MONTGOMERY COUNTY PLANNING DEPARTMENT
THE MARYLAND-NATIONAL CAPITAL PARK AND PLANNING COMMISSION

MEMORANDUM

REVIEW TYPE: Preliminary Plan Review

PROJECT NAME: Nehouse Property
CASE #: 120061130
REVIEW BASIS: Chapter 50, Montgomery County Subdivision Regulations

**PRELIMINARY PLAN
 NEHOUSE PROPERTY
 Montgomery County, Maryland**

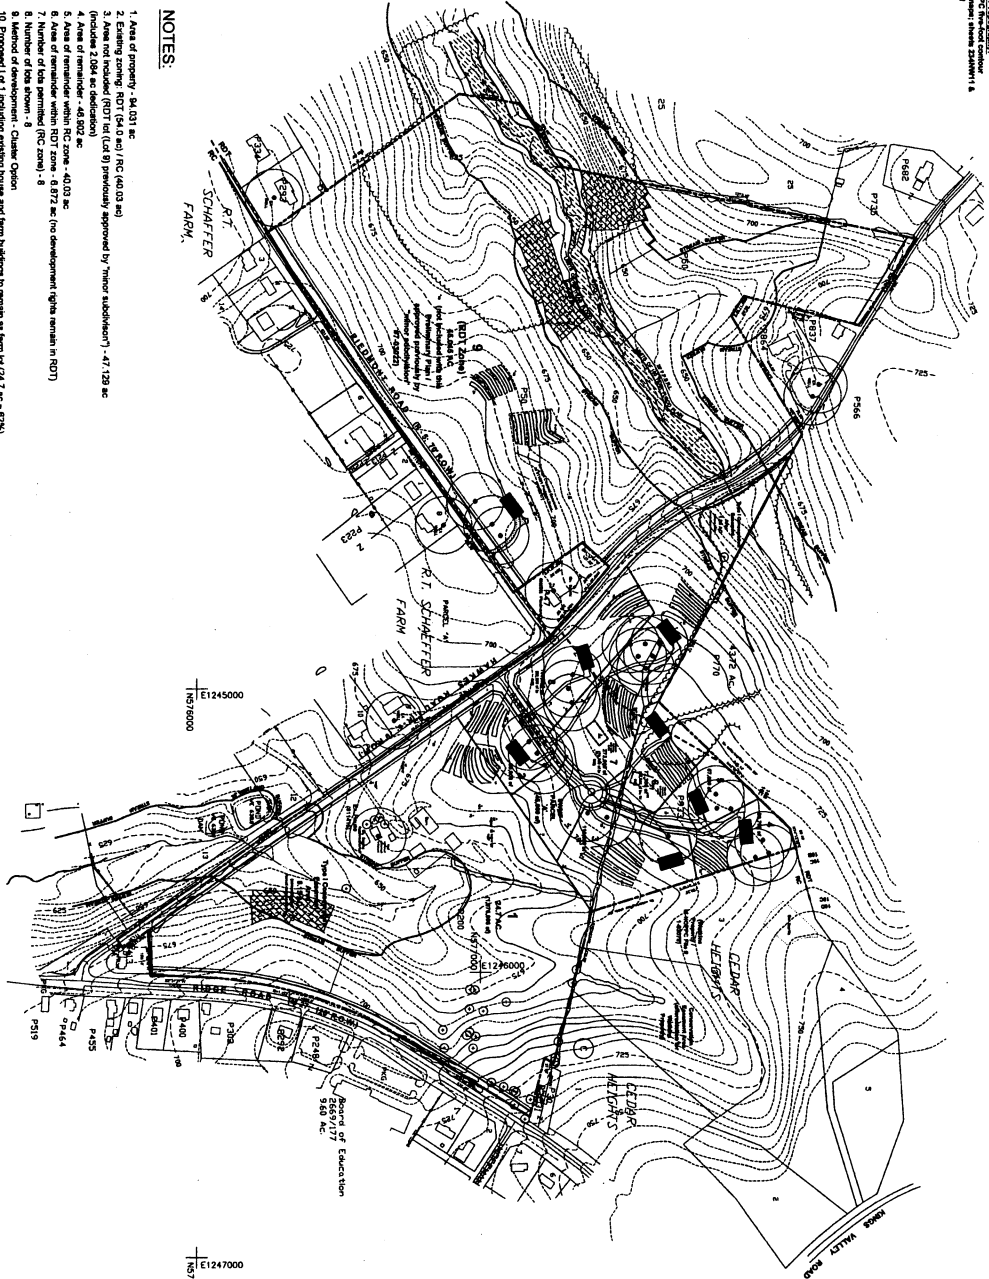
We have completed our review of the preliminary plan dated 12/29/05. This plan was reviewed by the Development Review Committee at its meeting on 06/05/06. We recommend approval of the plan subject to the following comments:

1. Show/label all existing planimetric and topographic details specifically paving, storm drainage, driveways adjacent and opposite the site as well as existing rights of way and easements on the preliminary plan.

2. Justify the proposed right of way shown for Hawkes Road. Once that is done, provide necessary dedication for Hawkes Road, Ridge Road and Piedmont Road in accordance with the Master Plan.

3. Full width dedication and construction of Hawkes Lane, aligned with Piedmont Road and as an open section tertiary residential roadway terminating in a cul-de-sac.

4. Grant necessary slope and drainage easements. Slope easements are to be determined by study or set at the building restriction line.
 5. We did not receive conceptual road profiles for Hawkes Lane. As a result, we are unable to offer any comments at this point.

7. Wells and septic systems cannot be located within the right of way nor slope or drainage easements.
 8. The plan should provide a horizontal alignment for Hawkes Lane which satisfies the design speed.

9. Show the locations of the proposed driveways for all houses on the preliminary plan.

10. We did not receive complete analyses of the capacity of the downstream public storm system(s) and the impact of the post-development runoff on the system(s). As a result, we are unable to offer comments on the need for possible improvements to the system(s) by this applicant.
Prior to approval of the record plat by the Department of Permitting Services (DPS), the applicant's consultant will need to submit this study, with computations, for review and approval by DPS. Analyze the capacity of the existing downstream public storm drain system and the impact of the post-development one hundred (100) year storm runoff on same.

12. Record plat to reflect a reciprocal ingress, egress, and public utilities easement to serve the lots accessed by each common driveway.
13. Record plat to reflect denial of access along Hawkes Road except for Hawkes Lane and existing driveway for lot#1.
